City of Garden City
Development Services Department
6015 Glenwood Street
Garden City, ID 83714

RE: Design Review Report and Decision Draft Report Response:
File Number DSRFY2025-0008

ANTIOCH APARTMENTS

Overall Fence Plan

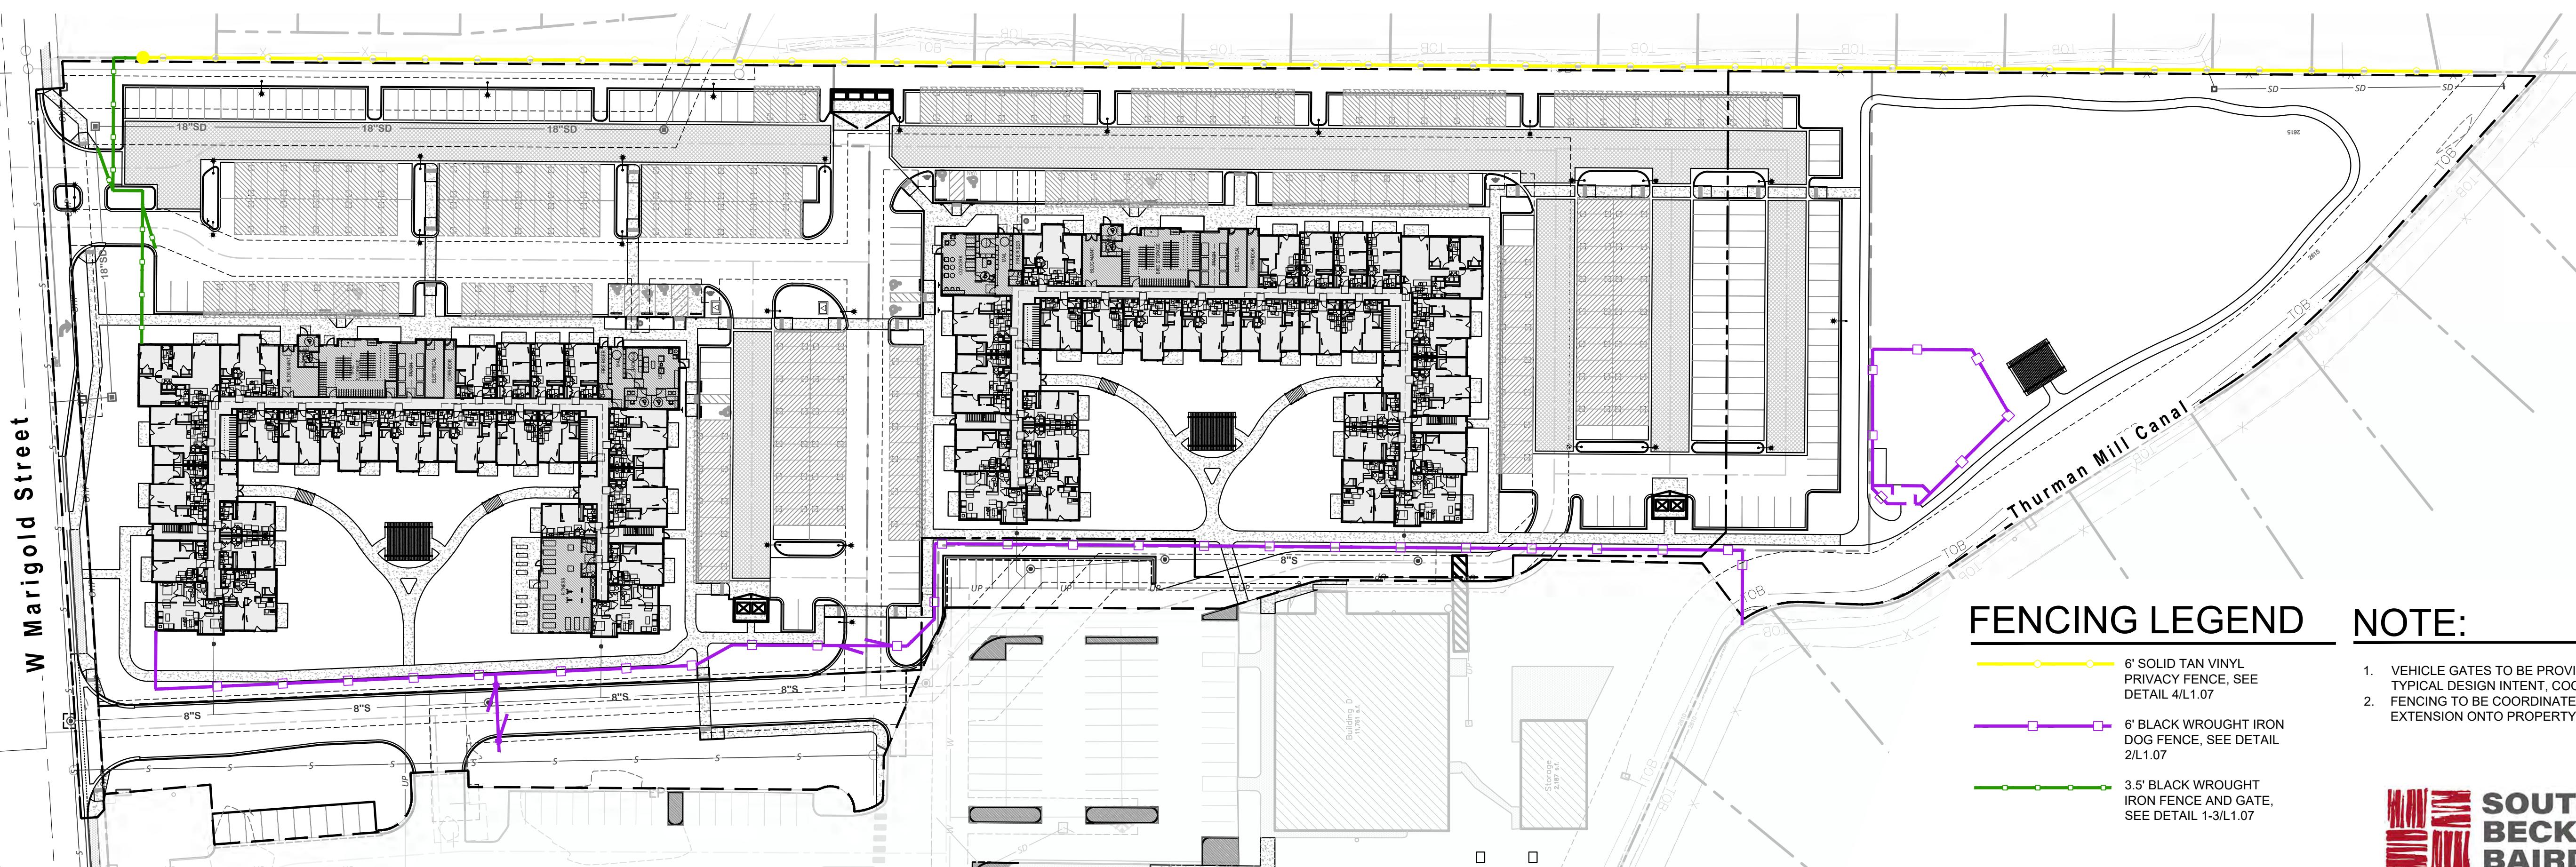
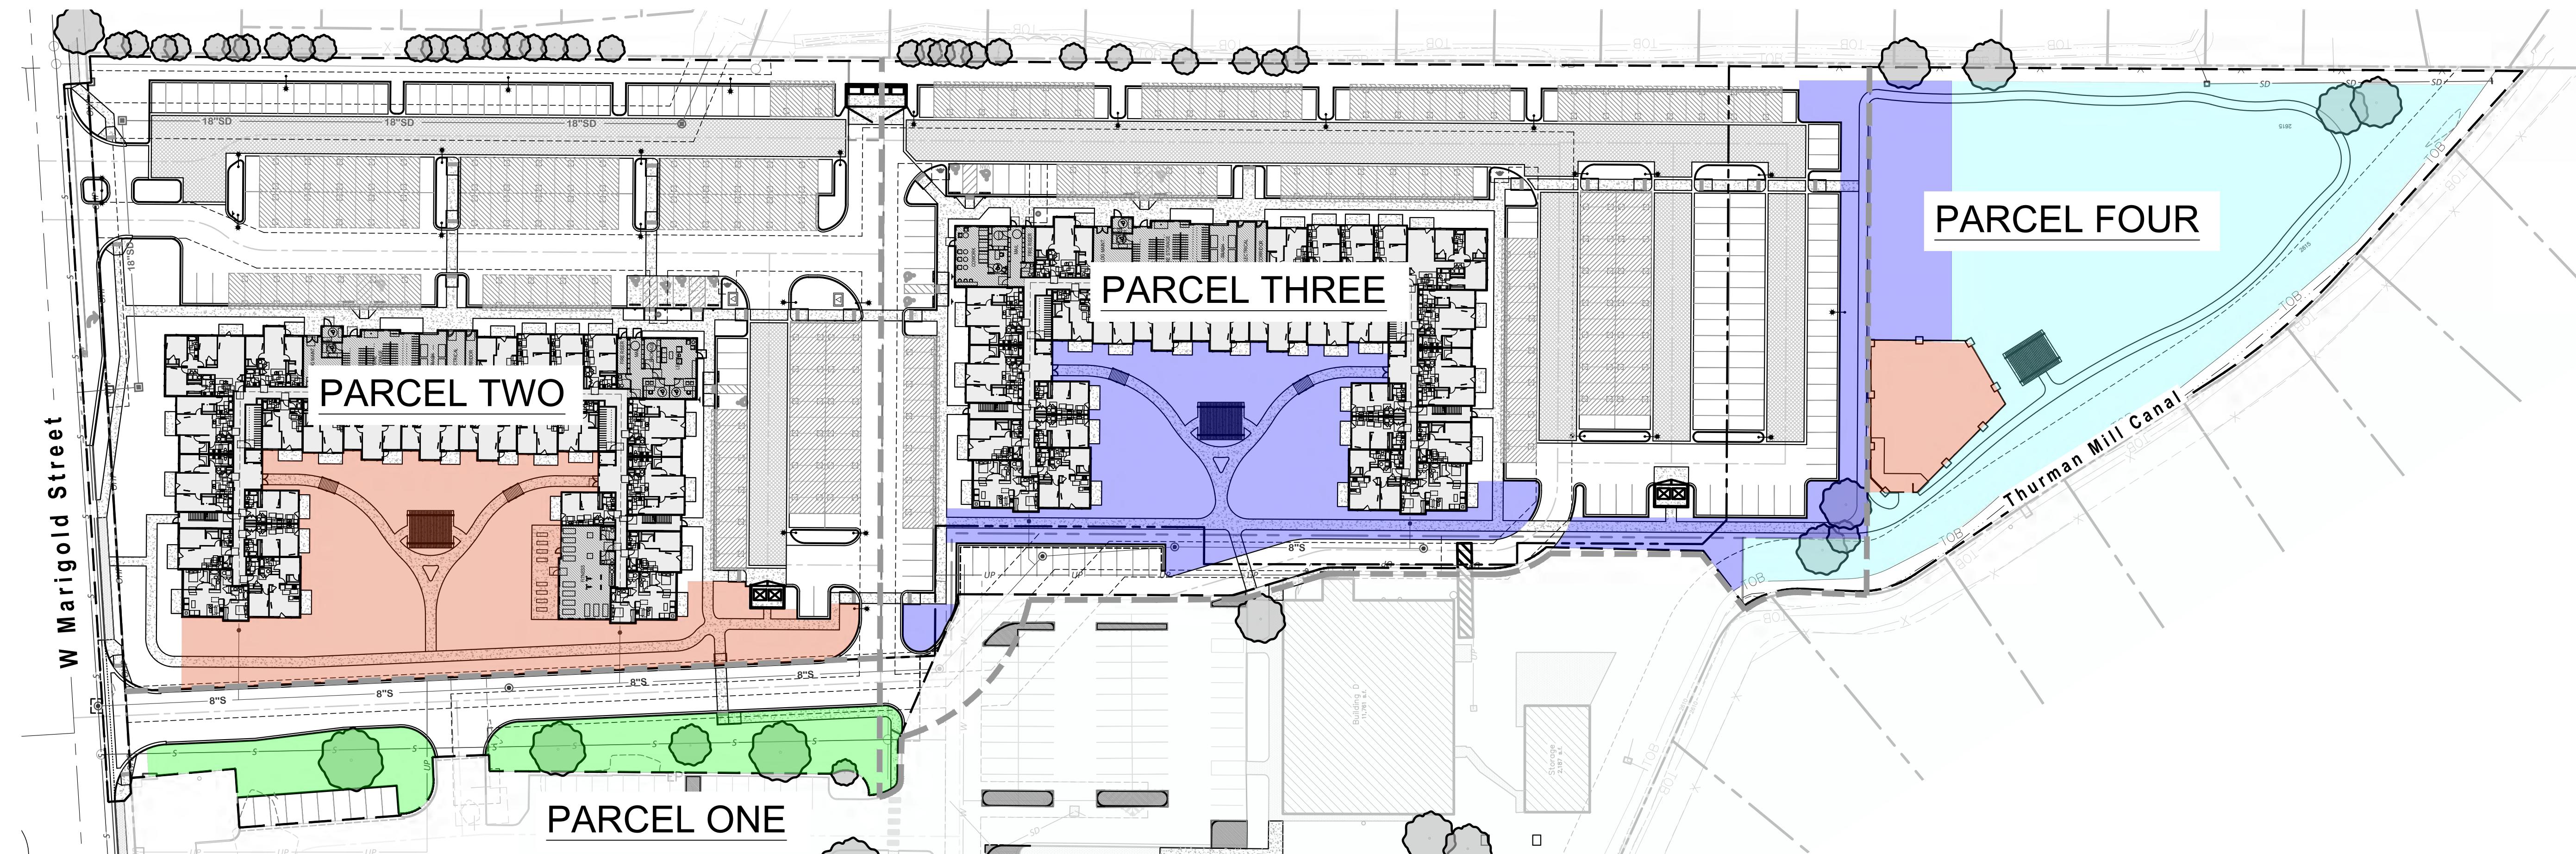
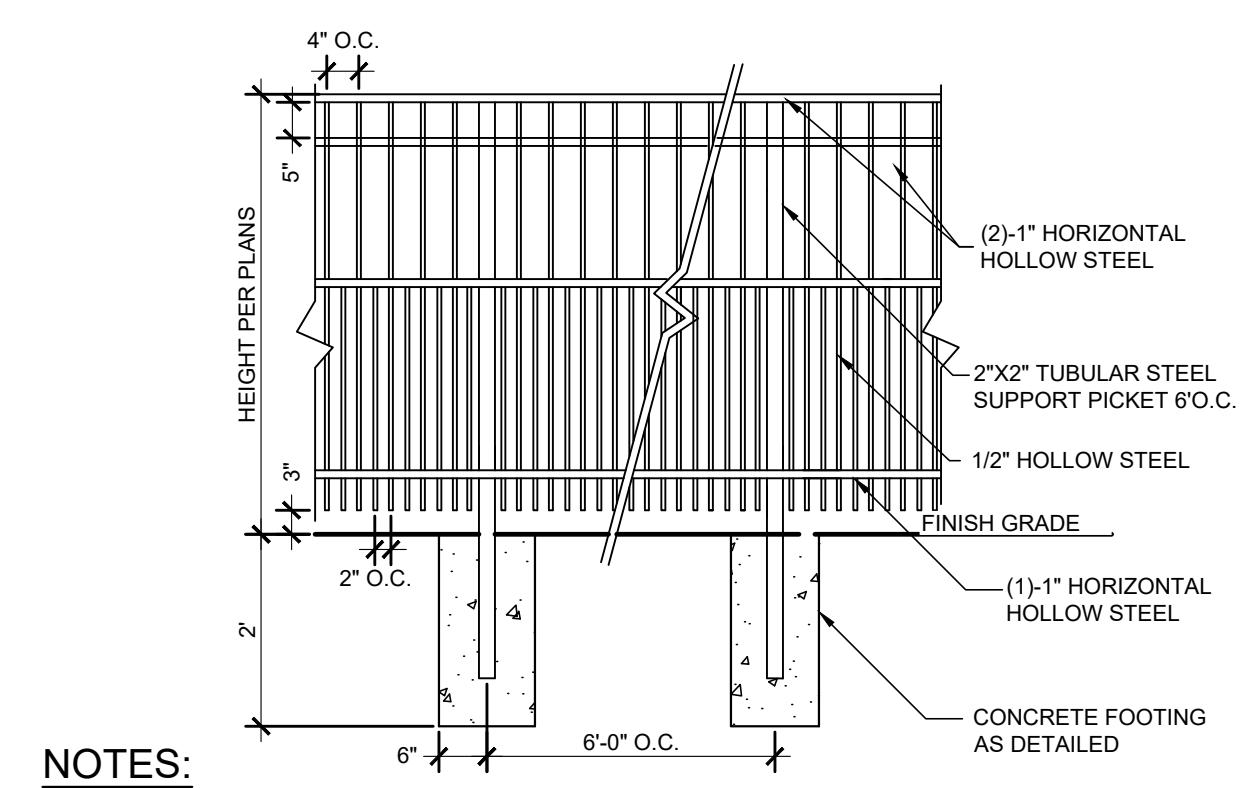
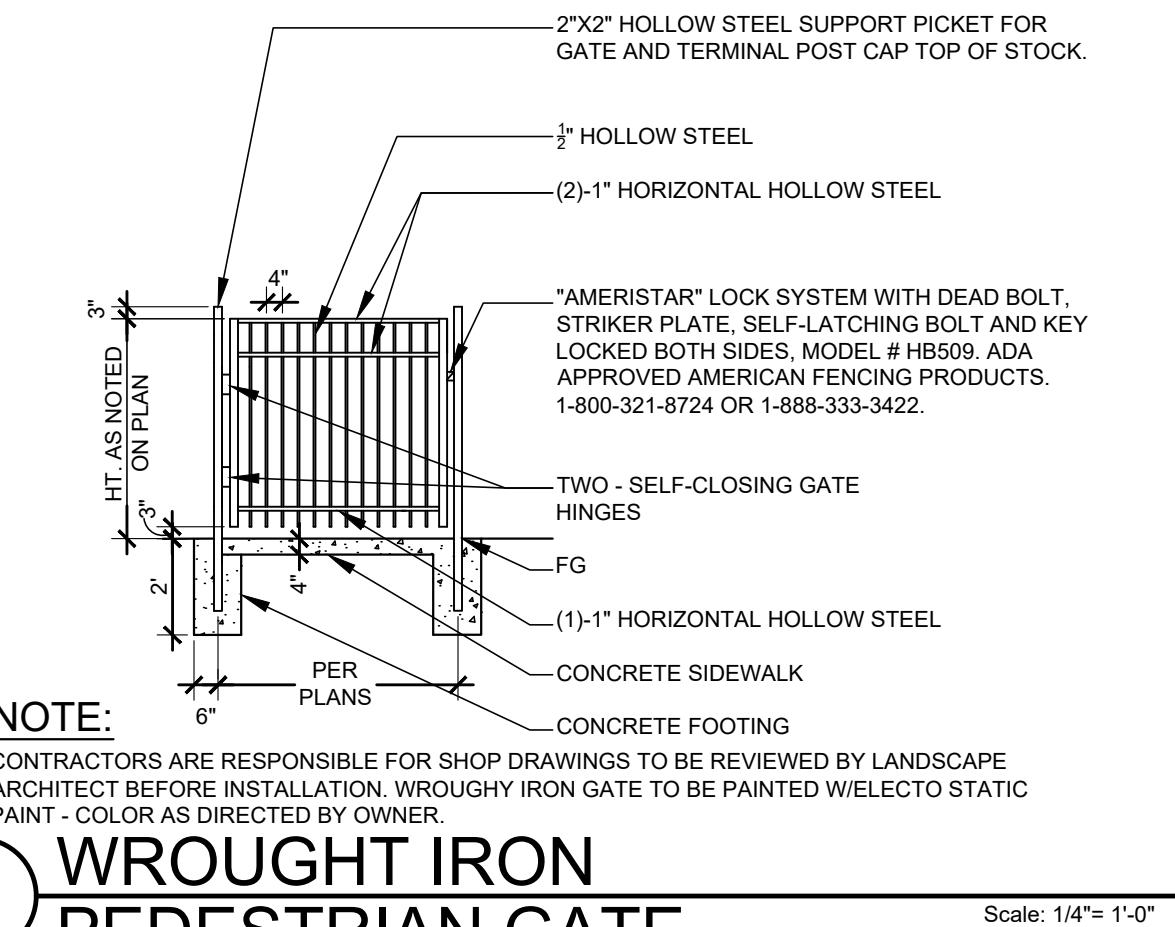
There is a proposed 6' tall solid vinyl privacy fence along the property boundary lines, and a 4' tall wrought iron fence internal to the development & 6' tall wrought iron fence along the frontage (Marigold) property line.

Fences within the front yard setback must be set flush with the building façade if they are greater than 3.5' tall. As such, the 6' tall wrought iron fence along Marigold is not compliant with code standards. Additionally, the perimeter vinyl fence is also not compliant with this code.

Response: *Fence heights within the front yard setback have been reduced to 3.5'. Vinyl fence is not listed as a prohibited fencing material.*

ARBORIST REPORT:

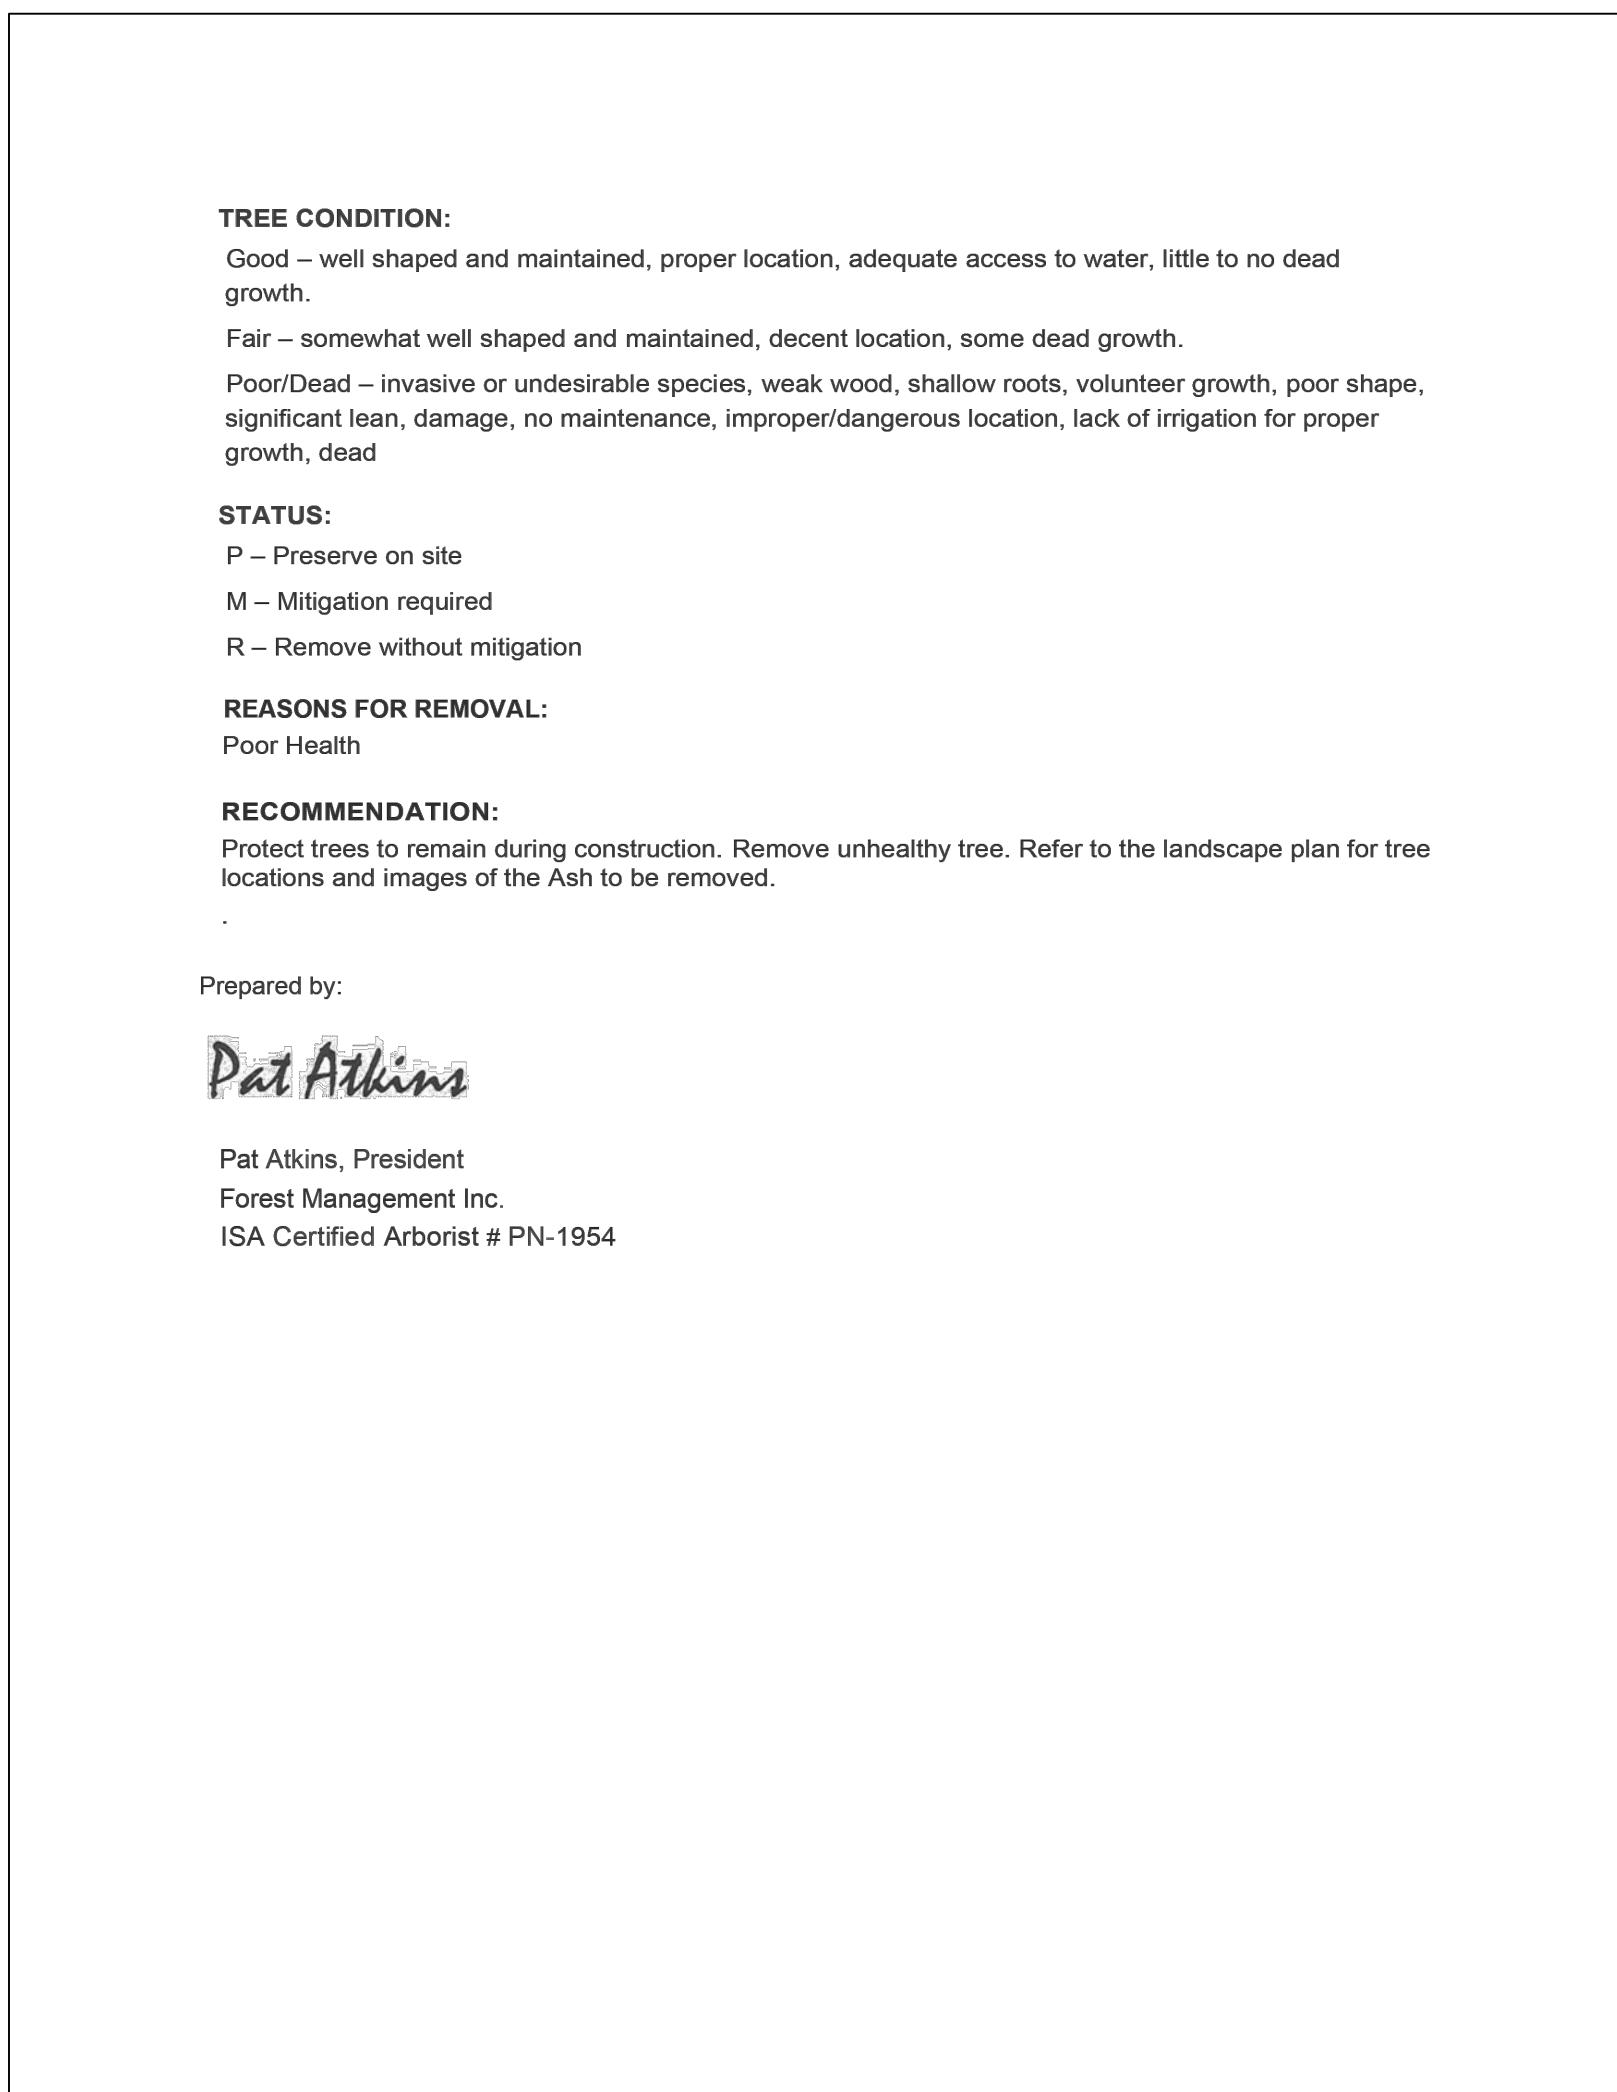
Comment:

Response: *Please see Arborist Report located on sheet L3.00.*
